NOVA-NEAR_DETECTOR
MUON CATCHER
CAM FOLLOWER HOLDER

SCALE	DRAWING NUMBER	SHEET	REV
1:1	3929.330-MB-489971	1 OF 1	A
CREATED WITH : Ideas12NXSeries		GROUP: PPD/MECHANICAL DEPARTMENT

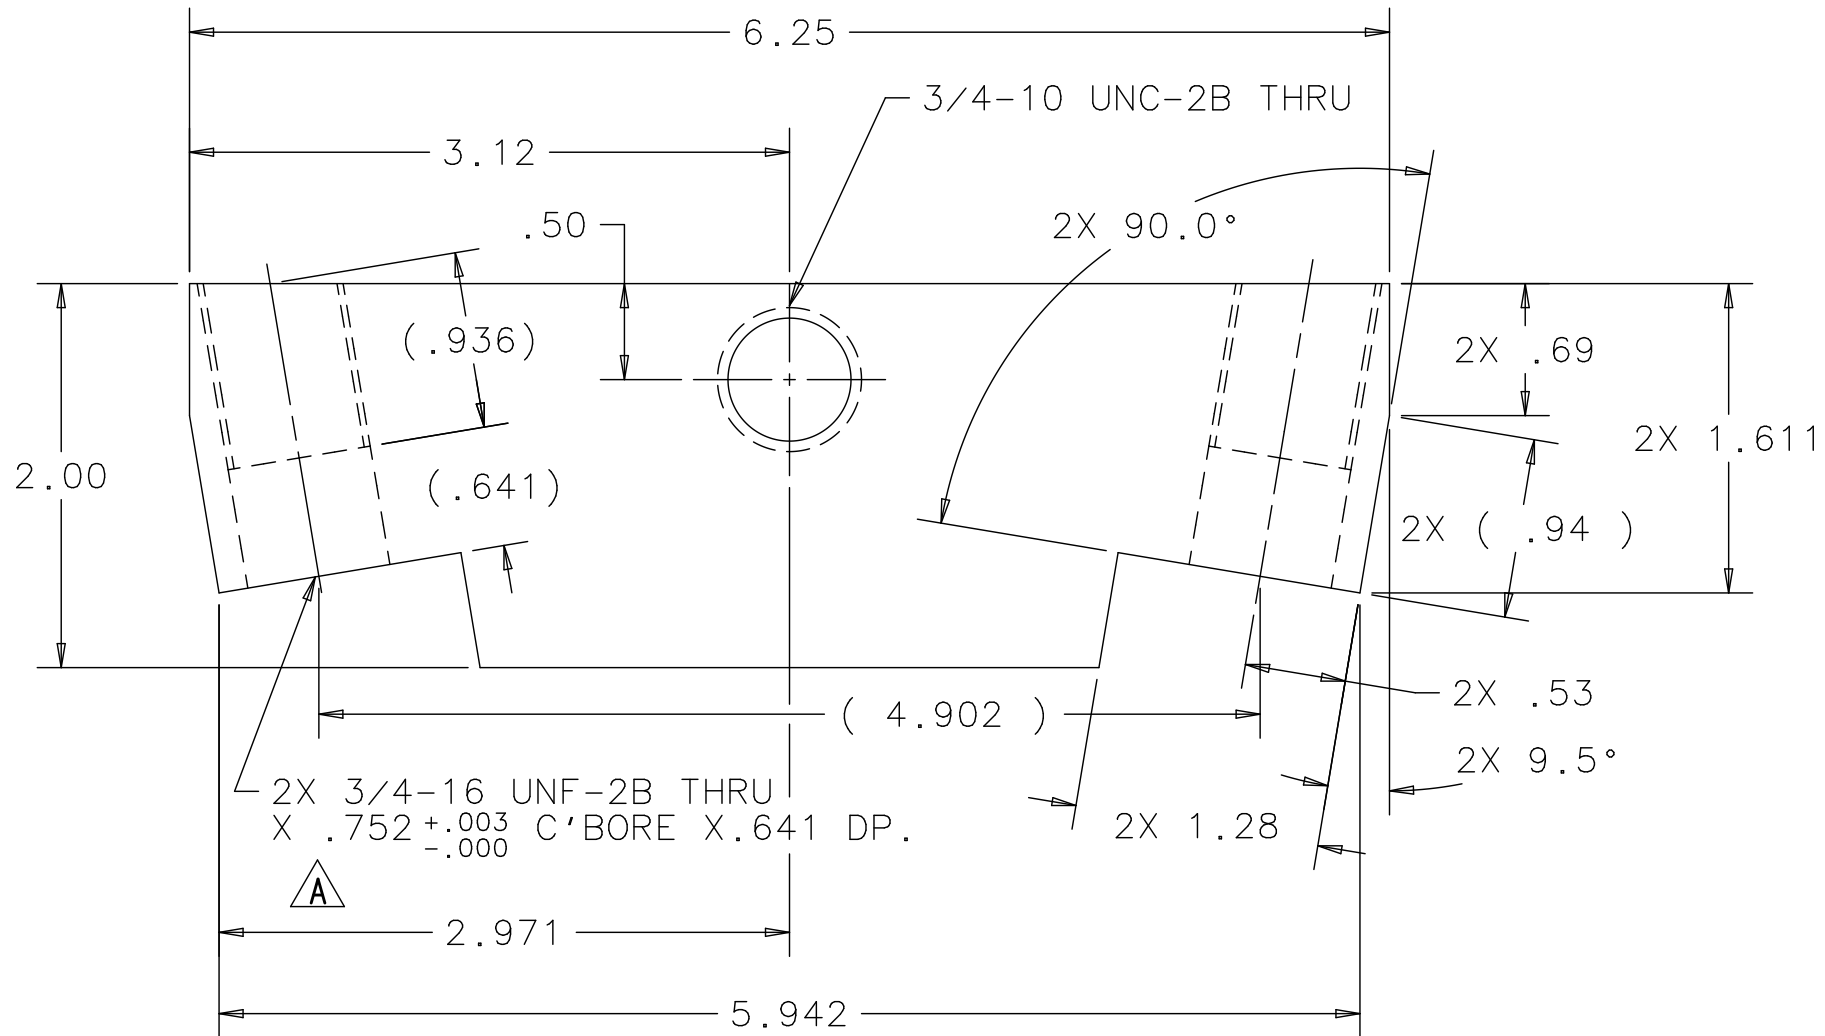
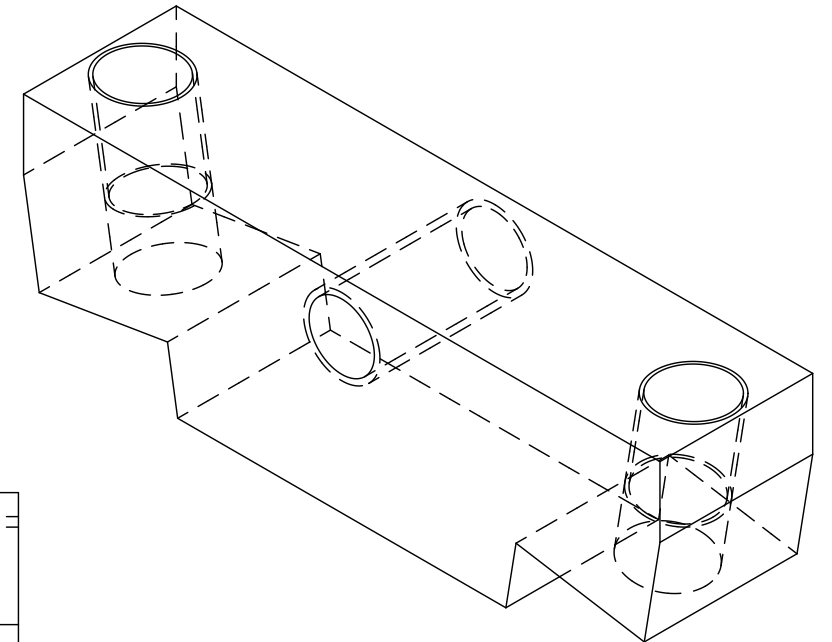
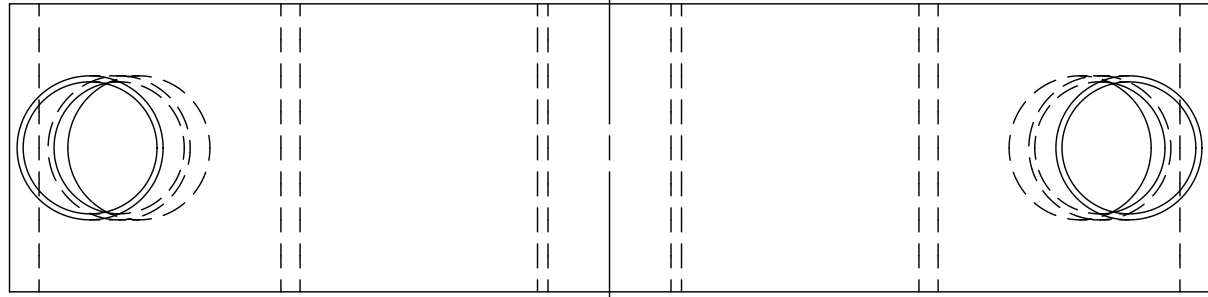
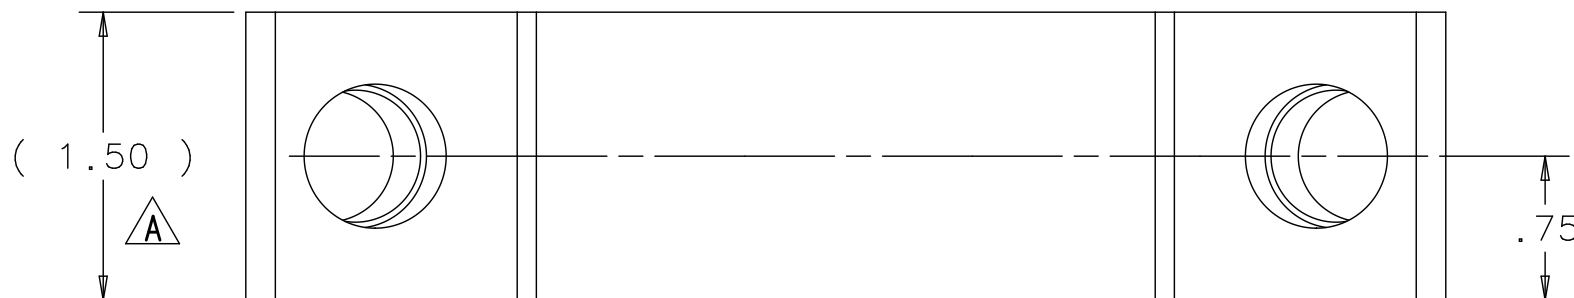
REV	DESCRIPTION	DRAWN	DATE
		APPROVED	DATE
A	PLATE WAS .75 THICK NOW 1.50 TAP HOLE WAS 5/16 NOW 3/4 PART REDESIGNED	G SMITH	19-JUL-2013
		D FRIEND/E VILLEGAS	19-JUL-2013
